KNOXVILLE/KNOX COUNTY METROPOLITAN PLANNING COMMISSION USE ON REVIEW REPORT

▶ FILE #: 3-F-06-UR AGENDA ITEM #: 78

PROPOSED USE: Self Storage Facility

MPC March 9, 2006 Agenda Item 78

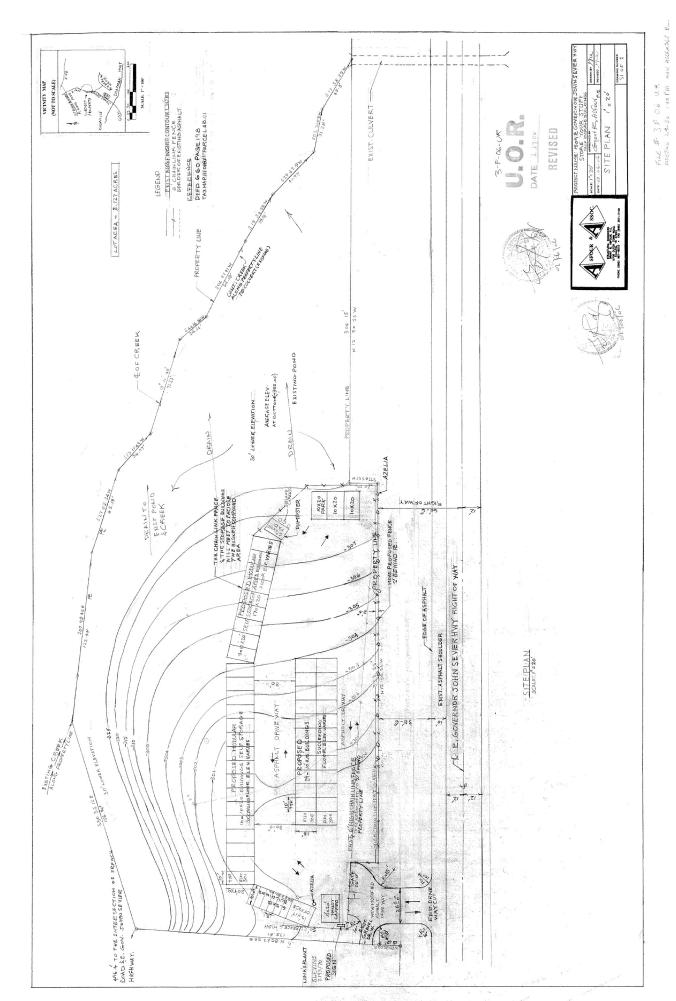
- 2. The access drive to the storage facility and all driveways around the storage buildings must be paved to meet the standards of the Knox County Department of Engineering and Public Works.

- 3. The driveway radius needs to be increased from 10' to 25' according to the Tennessee Department of Transportation.
 - 4. The paved asphalt driveway aisle, when serving storage buildings on both sides, needs to be 30' wide. If only serving one side, than the driveway aisle only needs to be 26' wide.

with evergreen and/or deciduous plant material. The proposed fence needs to be shifted 4' toward the storage buildings to provide space for landscaping.

- 7. A joint-use agreement providing driveway access to adjoining property will have to be filed with the Tennessee Department of Transportation.
- 8. A Highway Entrance Permit will have to be issued by the Tennessee Department of Transportation.
- 9. Meeting all applicable requirements of the Knox County Health Department.
- 10. Meeting all applicable requirements of Knox County Engineering.
